**RESPONSE TO THE SECRETARY OF STATE FOR ENERGY SECURITY AND NET ZERO'S REQUEST FOR INFORMATION AND UPDATES (DATED 3/3/23) FROM DAVID LANGLEY**

**NOTE TO THE PLANNING INSPECTORATE – THIS IS ALL NEW INFORMATION AND RESEARCH NOT PREVIOUSLY SUBMITTED**

**Plate 2.2 - England South Coast Map showing the region and ten connection sites identified**

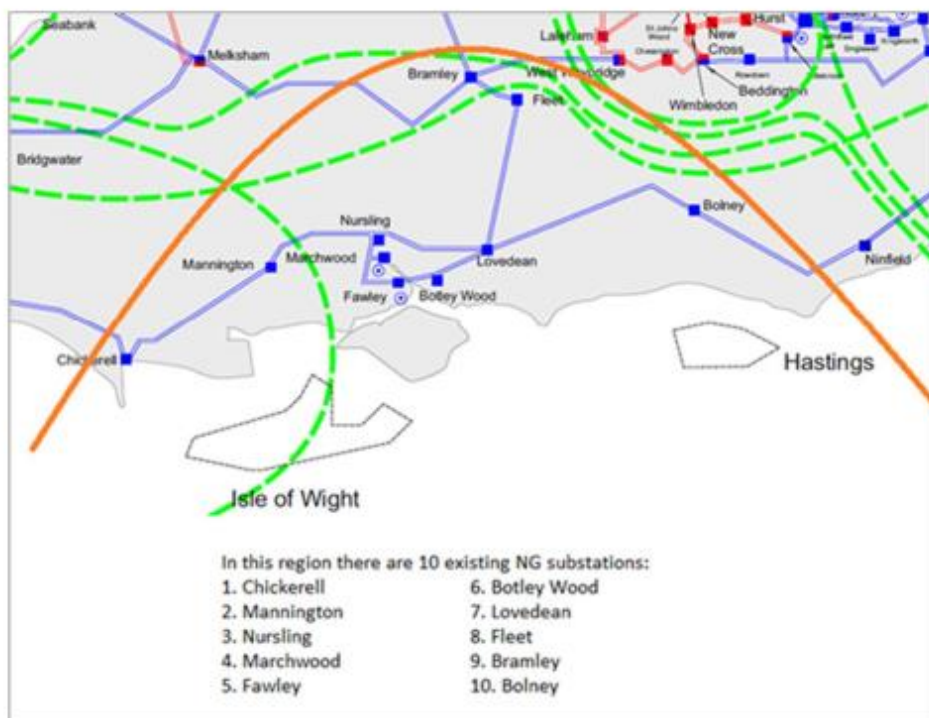
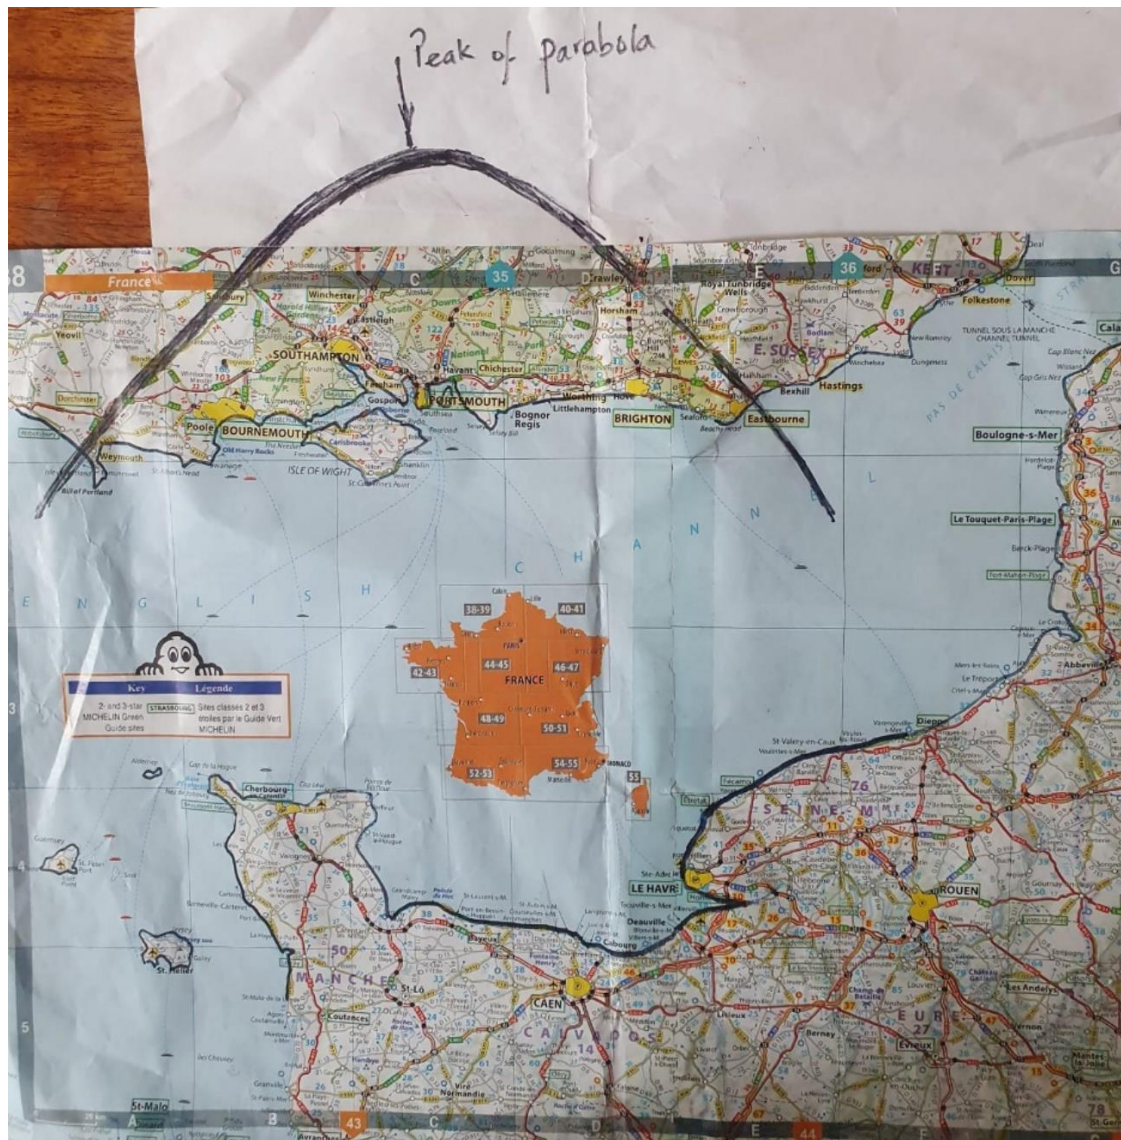
This diagram, Plate 2. 2 in the [Environmental Statement Volume 1](#) (PINS Ref.: EN020022) Chapter 2, page 2-8, is a map-like illustration representing part of the South coast of England. On closer inspection it is, in fact, rather confusing, having the word “Hastings” floating off-shore, nowhere near where Hastings actually would be on the map! Likewise, the Isle of Wight appears to be adrift!

This diagram/map has a parabola superimposed over it. The parabola encloses Portland Bill to the west and Eastbourne and Beachy Head to the East. The area within the parabola contains, we are invited to accept, those substations (10 in number), deemed suitable for the Aquind Interconnector to use as a connection point into the 400kv grid.

By implication, **substations outside this limited area are to be considered either not suitable, not viable or simply not to exist.** This misleading diagram has been used for all formal analysis; by the planning inspectors, by BEIS and by the Judge at the examination of the BEIS’ decision in the Royal Courts of Justice.

This parabola excludes, among others, one substation which could be far more suitable for connection into national grid lines, namely Ninfield.

We suggest that a revision to Plate 2.2 with France to the South, including substations to the East of Bolney and showing correct orientation in relation to the connection point near Dieppe, would have been a more true representation of the options for landfall on the south coast of England. Could it be that the planning inspectorate, the BEIS and the High Court Judge were all being guided by visual material that was misleading?

**The area covered by Plate 2.2 superimposed over a map of the English Channel**

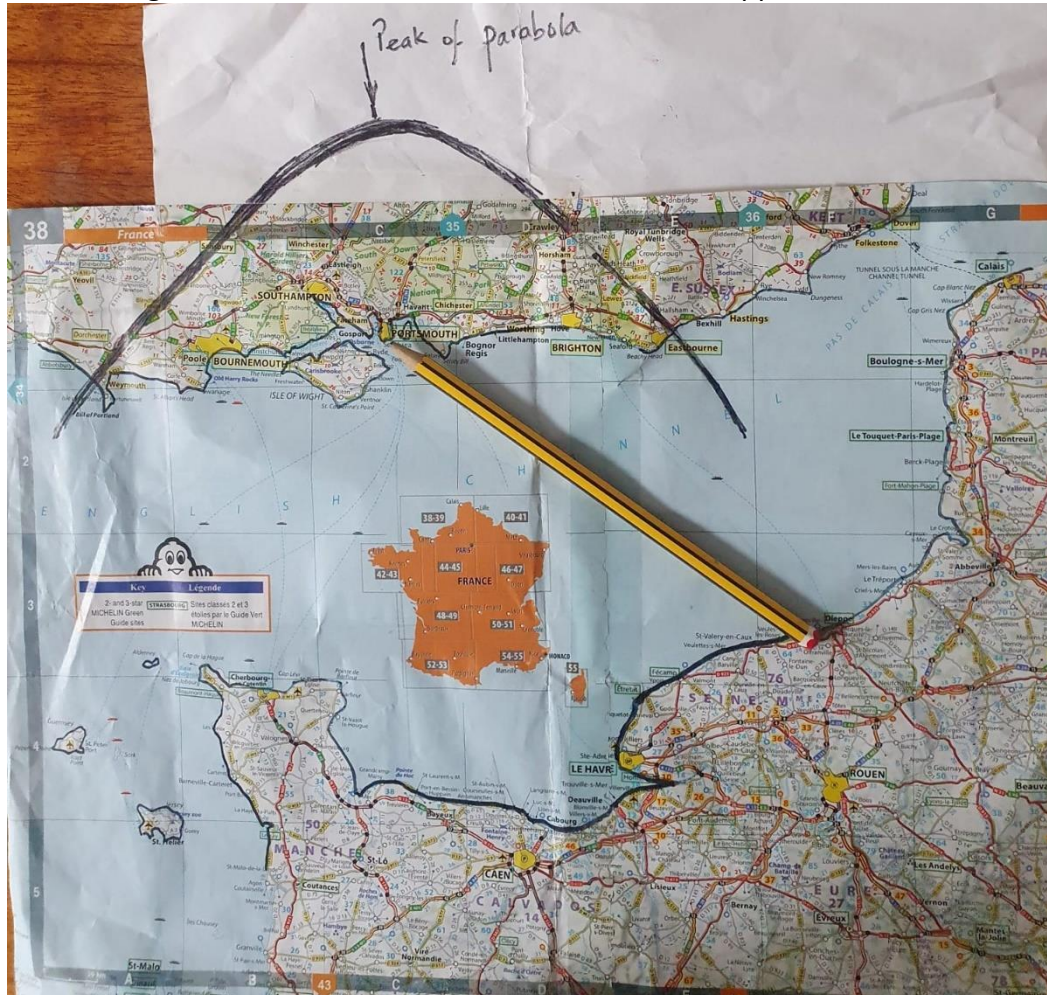
The misleading nature of Plate 2.2 is clearly evident when it is laid over a map showing the English Channel and the North coast of France from Calais in the east to Cherbourg in the West (see above). Such an overlaying clearly indicates the way in which misunderstanding is planted in an observer's mind.

Had the same parabola been used with Dieppe as the departure point on the French coast, different substations along the South Coast of England would have been included in the optioneering.
